Han® Hoods and Housings with Metric Cable Entries

The reason for the new product offerings is the publication of the international DIN EN 50262 metric thread specification.

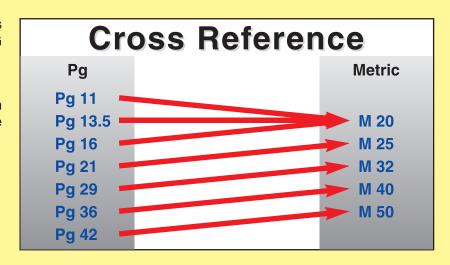
The existing PG series, PG 7 to PG 48 will be, in time, replaced by the metric series M 12 to M 63.

To differentiate the metric threaded hoods and housings from the previous PG versions metric types will be marked with M.

Please notice that the maximum cable diameter will be reduced by the new metric cable glands.
